# Coexistence between proposed Pacific DataVision LTE systems and existing Sensus FlexNet systems in the 900MHz band

Review and analysis by Real Wireless

# Summary of findings

#### Required attenuation (additional to PDV proposal) to protect -170dBm/Hz threshold

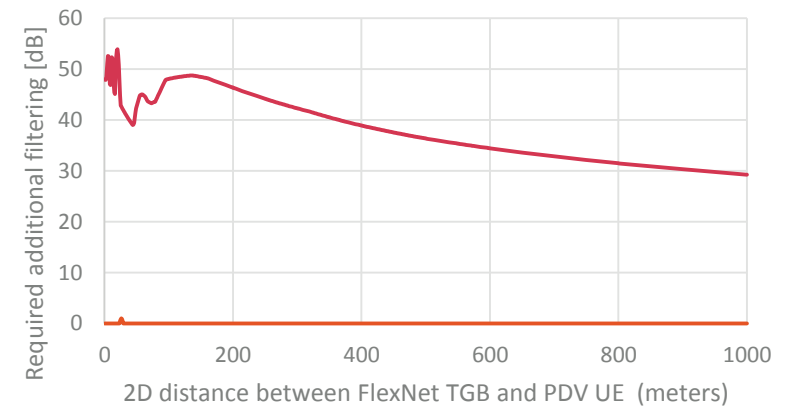
Our view of parameters indicates that at 54dB of additional attenuation could be required to adequately protect FlexNet base stations in this challenging case

# UE antenna gain and body loss

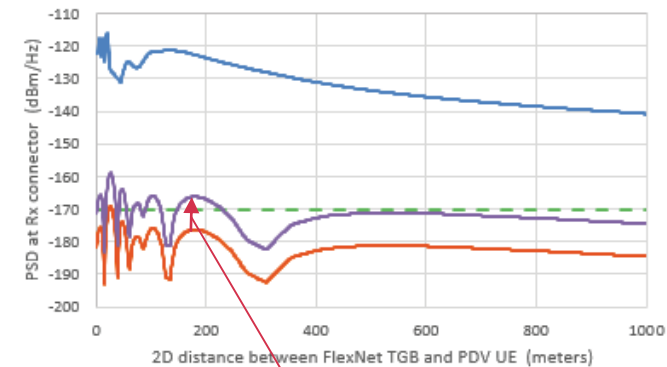
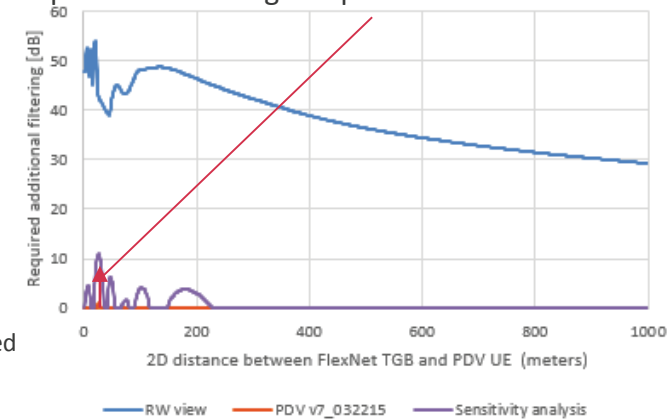
- PDV have assumed that the combination of the UE antenna gain and the head/body loss produce a composite gain of **-10dBi** citing FCC 12-151 Para. 142

- For standard UEs in the form of phones it is usual to assume an antenna gain of around 0dBi (see for example ITU-R and 3GPP system simulation assumptions [1][2][3])

- Body loss is entirely dependent on the way in which the UE is held, and on the orientation of the user with respect to the Flexnet system. Also if the UE is not already at its maximum transmit power, the body loss will cause the transmit power to increase, negating the impact of the loss. It cannot be relied upon to provide protection against interference.

- Hence our view is that a more appropriate value for the composite loss is **0dBi**
- We note however that UEs may not be smartphones, but could be for example consumer CPE intended for rural broadband applications. This can have an antenna gain as high as +10dBi, zero body loss and a high elevation, so our view by no means represents a worst case

Body loss has been overestimated: Impact of correcting this: +10dB worse interference

# LTE UE power backoff

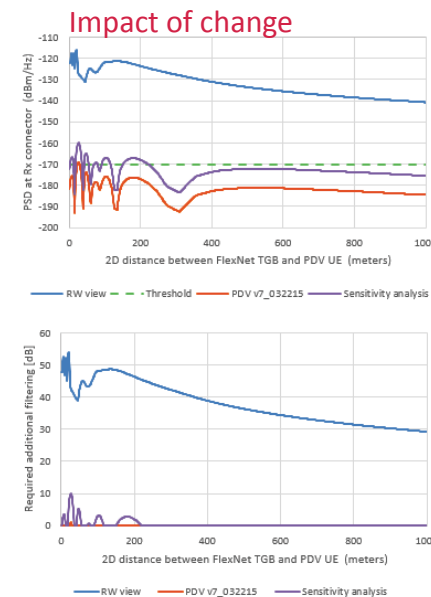
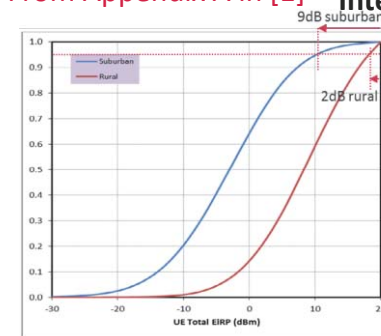
- PDV have assumed that the transmit power of the UE is reduced by **9dB**, citing “95% point of CSMAC WG-1 CDF curve for Suburban ”
- It appears that the reference is intended to be to [1]

- This report relates to sharing studies between terrestrial LTE UEs and meteorological satellites, whose receiver sees cumulative interference from UEs distributed over a wide area. We have several concerns with this approach:

- The calculations relating to the statistics of UEs distributed over a wide coverage area and many cells, not to the power which may be encountered by an individual UE at a particular specific location. Such statistics are irrelevant to the analysis of an individual path between a specific aggressor UE and its victim

- PDV have chosen the suburban curve. Many FlexNet systems operate in rural areas. The rural backoff value is closer to 2dB
  - PDV have chosen the 95% probability level. In order to protect FlexNet base stations we need to consider that a PDV UE may not be mobile, but could be permanently located close to a FlexNet TGB, so we are concerned with UEs at or near their maximum transmit power

- Hence we believe it is appropriate to evaluate interference based on **0dB backoff**

Impact of correcting this: +9dB worse interference

## “NB-BTS cable loss”

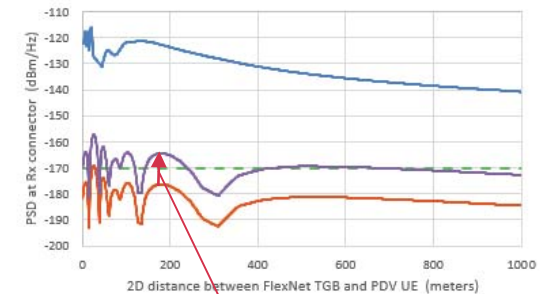
- PDV’s calculation includes a parameter called “NB-BTS Cable Loss”, set to a value of **4.0 dB**. No reference source for this parameter is provided
- In PDV’s model, this parameter directly reduces the level of the UE OOB emissions, so it appears in fact to be applied as a UE feeder loss
- The UE feeder loss would in practice be treated as part of the definition of the UE antenna gain, with no separate parameter necessary
- It appears therefore that PDV have mistakenly included this parameter and it should be removed or set to **0 dB** to correctly determine the UE OOB level

PDV have mistakenly included a parameter which is not relevant.  
Impact of correcting this: +4 dB worse interference

# No of simultaneously transmitting PDV devices Interpretation A

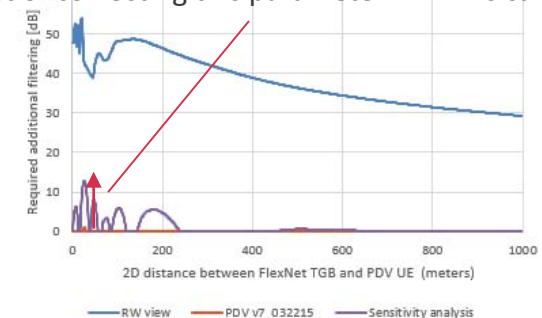
- PDV have assumed that only a single UE is transmitting in the channel, although they have included a parameter to set the numbers of UEs in their model
- In a 3 MHz LTE channel there are 15 individually addressable resource blocks, in each of which the base station (eNB) can schedule a single UE. In this situation each UE can simultaneously transmit at full power, creating a cumulative interference level 15x (12dB) greater than analysed

PDV have not included the effect of multiple UEs.  
Impact of correcting this: +12 dB worse interference

## -160dBm Reference Noise Floor – $N_0 + I_0$

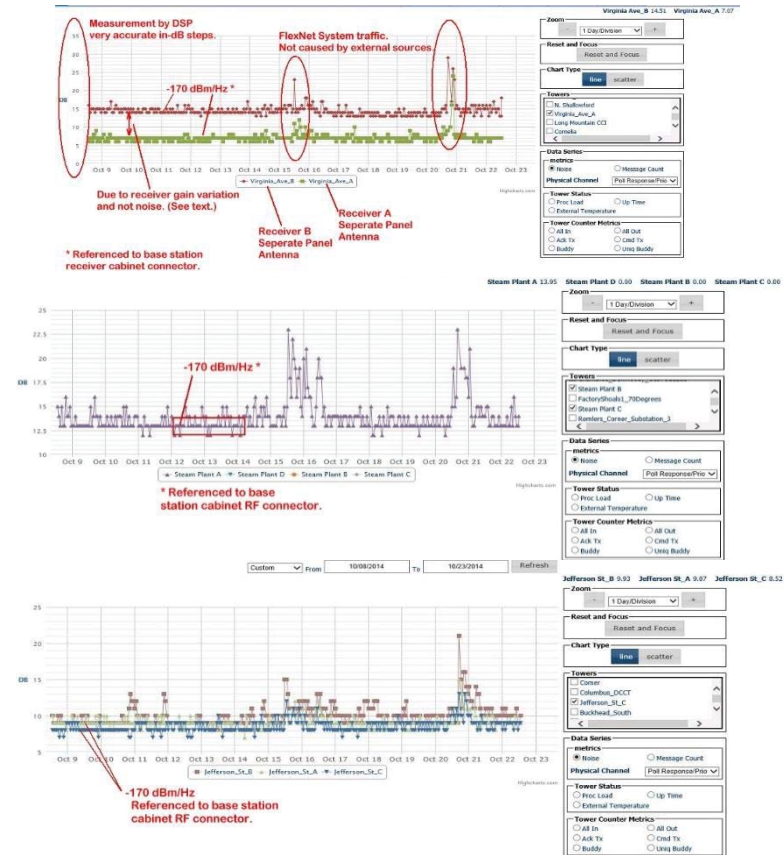
- The basic noise floor seen at a Sensus base station is at thermal noise PSD ( $kT = -174\text{dBm/Hz}$ ) plus the base station system noise figure (4dB based on Sensus data) –  
i.e. **-170 dBm/Hz**

- The noise floor *may* be raised at individual sites by environmental noise
- PDV has included a noise margin of 10dB, resulting in a 9.5 dB noise rise to **-160.5 dBm/Hz**. This is based on their reading of a collection of studies which made in various environments, but they note that: “studies...were difficult to find...deliver values from a limited amount of samples...had to be extrapolated” suggesting a low confidence in their chosen value.

- We note that environmental noise arises in practice from specific sources which vary substantially with location, time and frequency. At any given base station the environmental noise may be much lower than these values.

- In contrast to the generalised data which PDV have used, Sensus have made explicit measurements at a several base stations over several years

# Base station antenna radiation pattern and gain

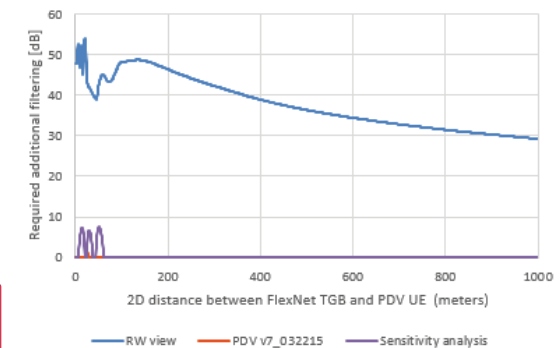
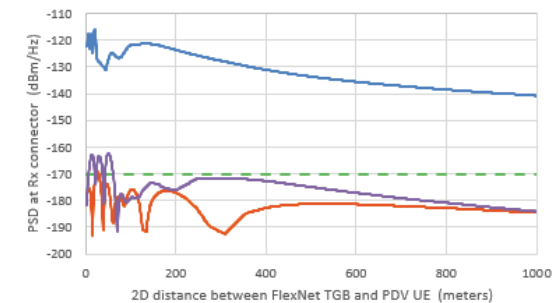
- In the first version of their model [1] PDV quoted antenna pattern BCD-87010-EDIN-6: we have checked the manufacturer's website for this and compared: the pattern is entirely different from that used by PDV – this appears to be a mistake
- In the newer version of the model [2] PDV quote antenna type BCD-87010-EDIN-1-25, but the pattern data used is identical to the previous version: we cannot find this on the manufacturer's website
- The most commonly used patterns in the FlexNet network are the BCD-87010-25 series model: we propose to use the BCD-87010-6-25 which has 6 degrees of electrical downtilt
- While the antenna gain is unchanged, the increased downtilt results in peaks of interference around 7dB higher and extended over a greater ranges of distances

PDV appear to have used the wrong antenna radiation pattern: a realistic pattern increases short-range interference by around 7 dB

# Base station antenna height

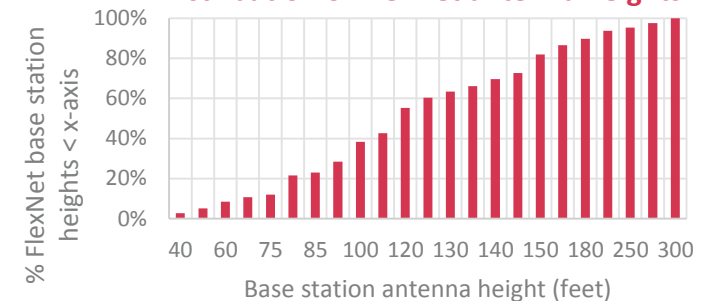
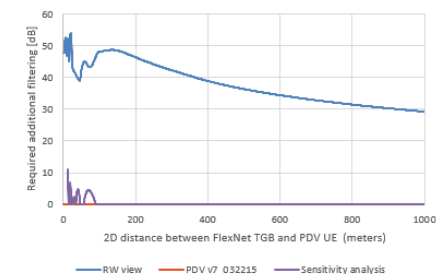
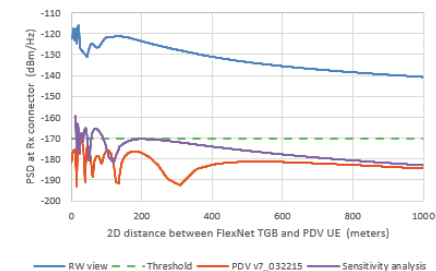
- PDV have assumed a base station antenna height of **148'** (45m)
- Analysis of the actual antenna heights of FlexNet base stations shows that:
  - The median (50%) antenna height is between 110'-120'
  - Around 20% antennas are below 80'
  - Around 10% of antennas are below 60'
- PDV have chosen a non-typical height
- Lower antenna heights reduce the path loss to the UE, increasing the maximum interference level
- In order to protect most base stations , we select the 10% value of **60'**
- The impact of this change is shown opposite

PDV have overestimated the height for the FlexNet antenna  
Correcting this increases the interference level by up to 10 dB

## Propagation model (2)

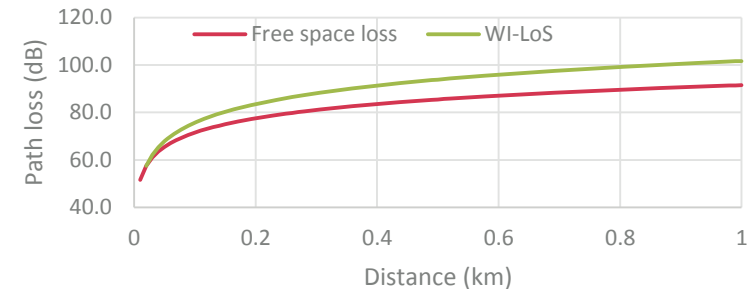
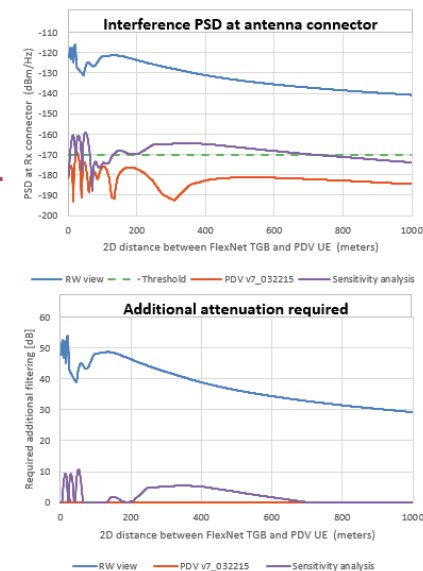
- PDV have used the **Walfisch-Ikegami LoS model** in their calculations. They have made provision for calculations using the free space loss, but have not applied this and the model does not appear to function correctly for this case (it reverts to the “WI-LOS” model even when “Free Space Model” is selected)

- The Walfisch-Ikegami model is a theoretically-based model with empirical extensions, published by a European research project COST-231 [1]. The full text of the model description shown opposite.

- When a line-of-sight path is present and the distance is greater than 20m, the model reverts to an empirical adjustment intended to represent the presence of scattering within an urban canyon environment

- It has several key limitations in this applications:
  - It is not defined for use below 20m (it matches free space loss at that range, but is not intended to be used below that range)

- It is not applicable in locations represented by anything other than a street canyon, which is an environment rich in multipath and urban furniture features.

- It is only intended for base station heights below 50m
- For short distances, propagation models converge to free space loss formulation and parameters. The free space loss model is commonly used in co-existence studies to model short and line-of-sight interference paths

- We therefore recommend the use of the **free space loss model** at all ranges where there is potential for a line-of-sight
- We note that indeed at short ranges <20m PDV have adopted the free space model (which is not specified by the Walfisch-Ikegami model)

- Since Walfisch-Ikegami exceeds the free space loss model at all ranges > 20m, it risks understating the extent of interference
- It has a small (1.4 dB) impact on interference at a range of around 30 m taken on its own
- However when taken together with the change to the antenna pattern the impact is compounded and results in a 3.5 dB increase in interference (on top of the 7 dB due to the antenna change)

# Maximum attenuation due to antenna pattern

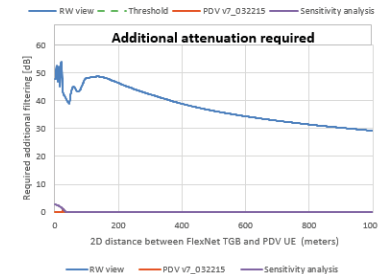
- Antenna patterns are measured in anechoic chambers, which exhibit no multipath propagation
- In practical environments even small amounts of multipath can substantially reduce the depth of antenna pattern nulls (see example from [1]), so these should not be relied on to provide interference protection in particular directions
- PDV has **not considered** this effect
- In order to deal with this it is typical to cap the attenuation from the antenna at some level, typically around 20 dB (see [2, 3])
- The impact is to significantly increase the level of interference at the shortest ranges, resulting in an extra 2.5 dB attenuation

# FlexNet Endpoint antenna gain and cable loss

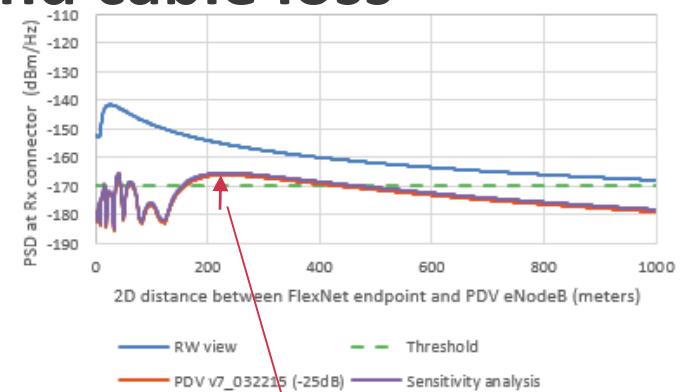
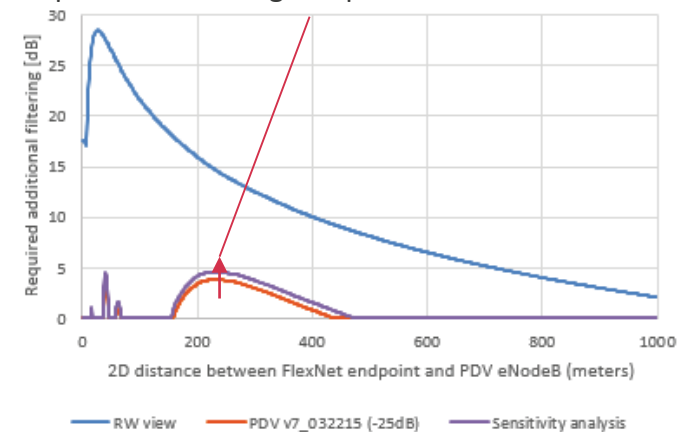
FlexNet Endpoint antenna gain has been underestimated and cable losses have been overestimated: Impact of correcting this: +0.75dB worse interference

# Base station antenna height

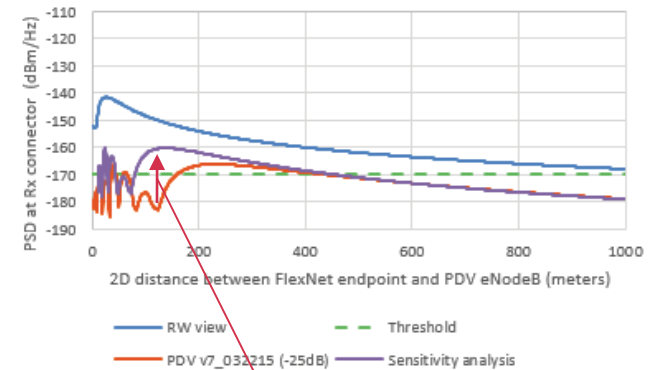
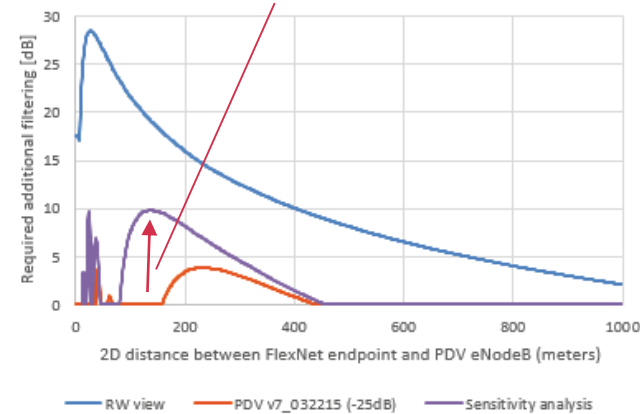
- PDV have assumed a base station antenna height of **98.4'** (30m)
- This is relatively high and LTE eNBs are often operated at lower heights
- In order to protect the Endpoints, a lower antenna height should be considered. Our view is that the height of **60'**, as in the PU2FT calculation (PDV UE to FlexNet base station), should be considered
- The impact of this change is shown opposite

# Maximum attenuation due to antenna pattern

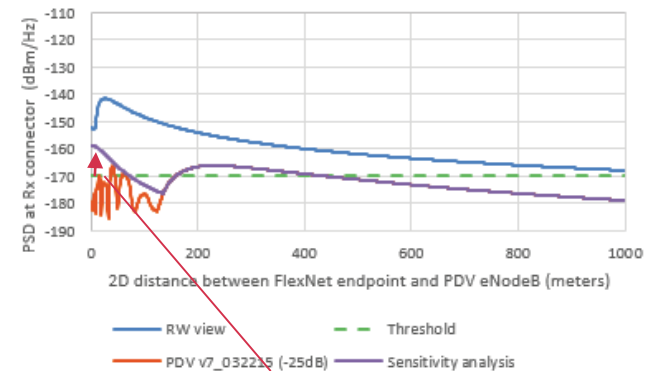
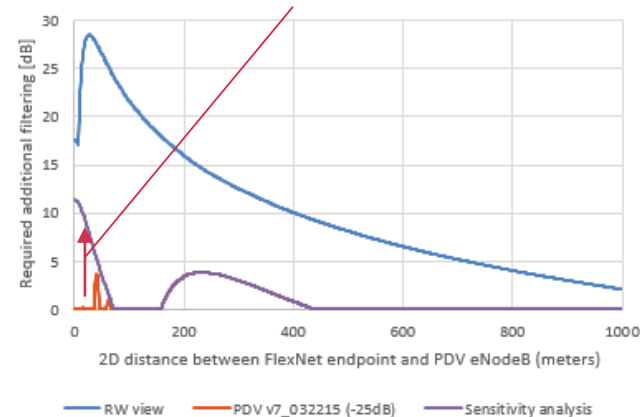
- As discussed earlier, multipath tends to fill base station antenna nulls so these should not be relied on to provide interference protection in particular directions
- PDV has **not considered** this effect
- Capping the attenuation from the antenna at some level, typically around 20 dB (see [2, 3])
- The impact is to significantly increase the level of interference at the shortest ranges, resulting in an extra 8 dB required attenuation
